20A Ferncroft Avenue
London
NW3 7PH

Basement Impact Assessment
Audit

For
London Borough of Camden

Project Number: 13398-02
Revision: F1

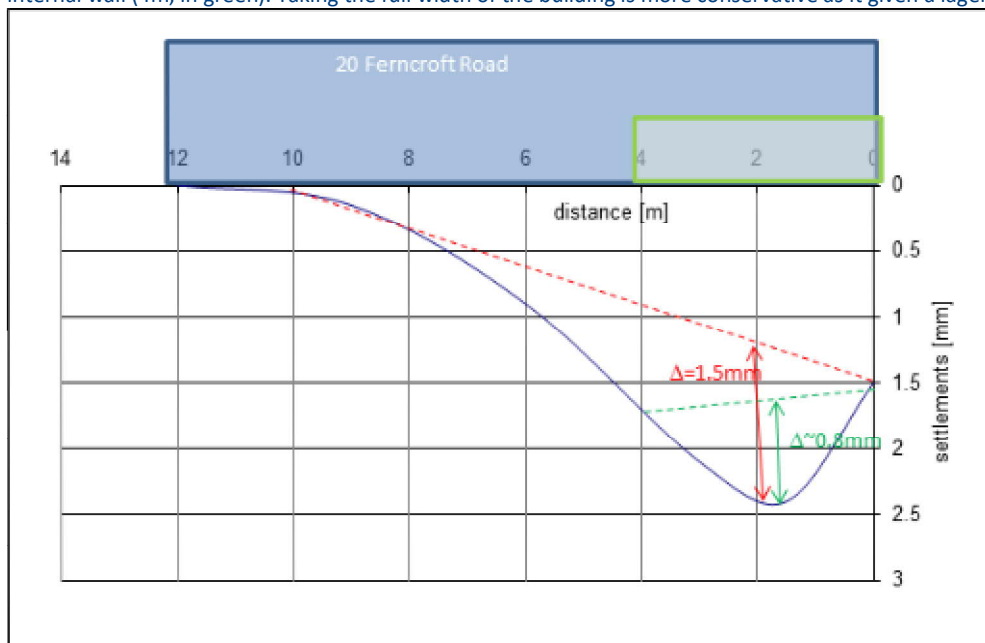
GCG note that it is conservative to calculate strain over the full building width rather than consider an internal wall with a smaller dimension. As the strains depends on the distance over which the movement occurs, the profile of the deflection curve and the breadth of the affected building, a sketch of the ground movement profile and resultant Δ plotted against a section of the neighbouring building would be helpful.

Please see below the diagram that refers to the full width of a building, in accordance with CIRIA C760 and the length of a shorter internal wall (4m, in green). Taking the full width of the building is more conservative as it given a larger Δ .

excavation depth [m]	length [mm]	horizontal movements (differential) [mm]	Δ	ϵh	Δ/L
garage of 22FA	3.5	3000	1.5	0.8	0.050	0.0267
20 FA	3	12000	4.5	1.5	0.038	0.0125
20 FA 4m wall	3	4000	1.5	0.8	0.038	0.0200

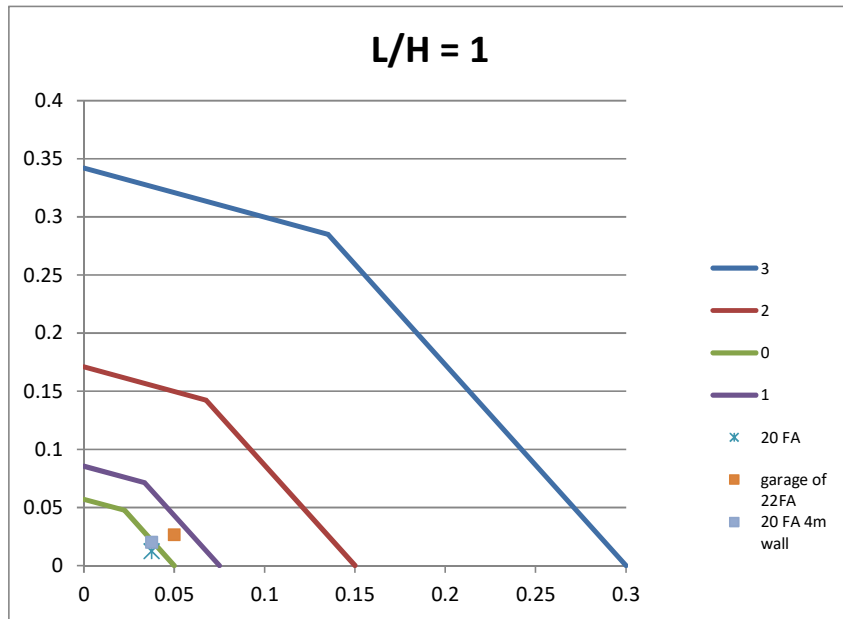
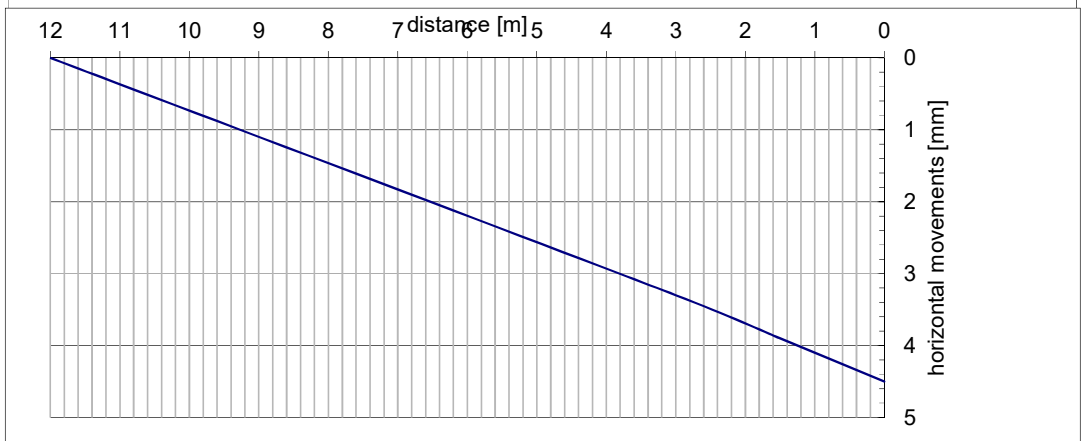
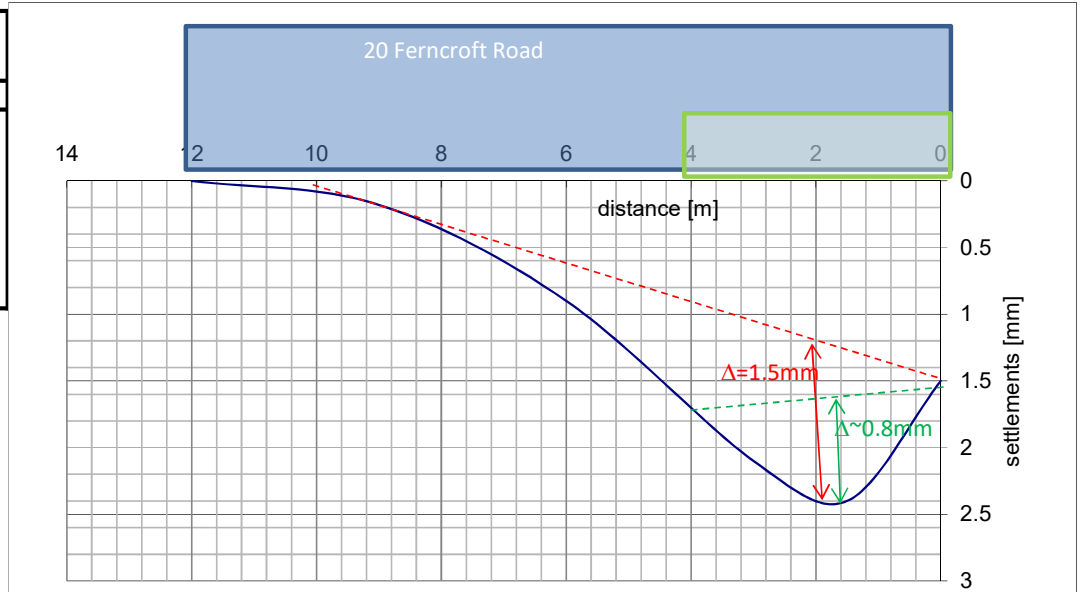
With respect to the category of damage/strain calculation, your chart shows that a 4m length of wall is more onerous. $\Delta/L = 0.8/4000 = 0.02\%$. $\Delta/L = 1.5/12000 = 0.0125\%$.

Just so that I understand, can you confirm the horizontal strain and deflection ratio that you calculated for 20 Ferncroft Ave?

Please find attached the full output of the calculations for the site. I have also included the calculations for a 4m long wall. You will appreciate that the actual figures of distortions and horizontal strains are even lower than what we quoted in the report. This is due to the fact that the values for 20 FA are fairly close to the boundary between Category 0 and 1 and we conservatively quoted Category 1, which also accounts for any further cracks due to underpinning.

I am not sure I really understand the issue of a shorter wall. It is unconventional for an assessment of this type to consider internal walls of unknown length and position, because the deflection ratio would vary depending on the length of the wall and its position in the house. In any case this is a check that should perhaps be done in a situation when the structural stability of a building is at risk, but it does not seem to be worth the effort in a situation where the excavation is shallower than 4m and the estimated movements are lower than 5mm.

DRAWING TITLE
COMPARISON OF EXISTING AND PROPOSED HARD & SOFT LANDSCAPING AREAS

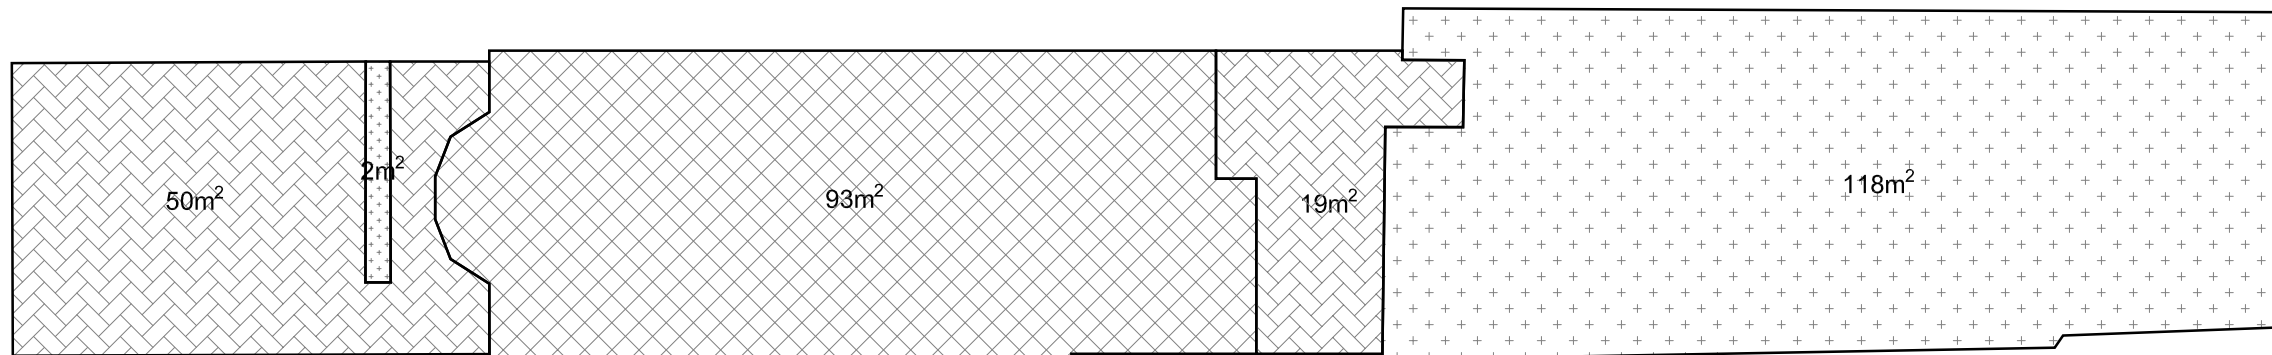
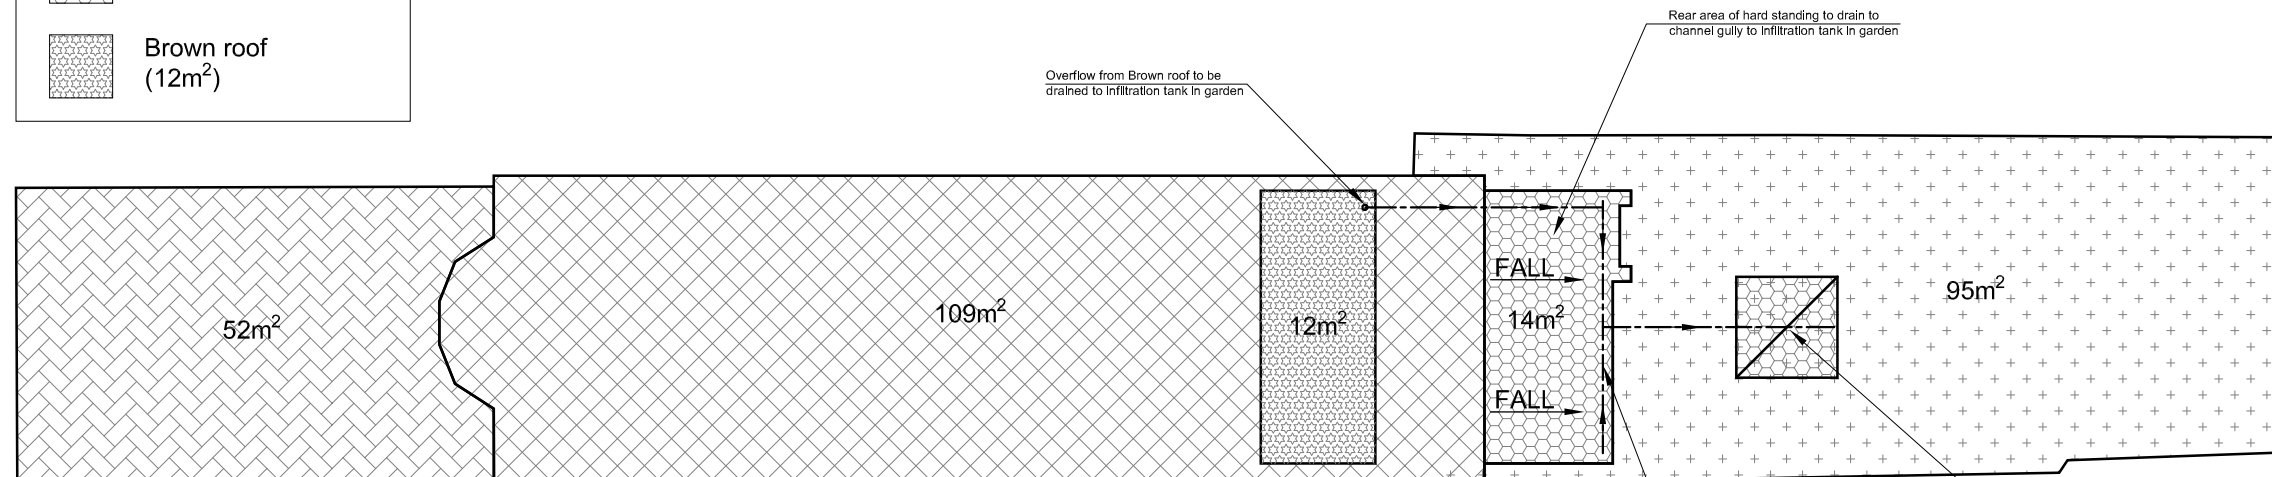
4	Stability	Consideration to be given to impact of tree removal.	Open – it is stated in GMA that current water demand of tree to be removed is low due to poor condition, therefore impact of removal will be small. To be confirmed by arboriculturalist.	
5	Hydrogeology / Hydrology	Impact of infiltration tank to be considered.	Open - Reference made in addendum to attenuation tank. Clarification required.

We shall now close out this query although we are still waiting for a statement with respect to changes in impermeable area, proposed mitigation measures and any impacts of those measures on surface water and groundwater.

Further to our phone conversation today we confirm there is an additional area of hard standing for the new development, this increase in area is equal to the rear paved terrace and the brown roof area, the design is for these areas to drain into the infiltration tank so that the surface water drainage to landscape areas is the same as the existing site condition

I attached our update drawing confirming the rear terrace area and brown roof area will drain to the garden Infiltration tank.

A	Confirmation of increased external hard standing to drain to infiltration tank to maintain existing surface water infiltration condition	GB	19.05.20
MK	REVISION	BY	DATE
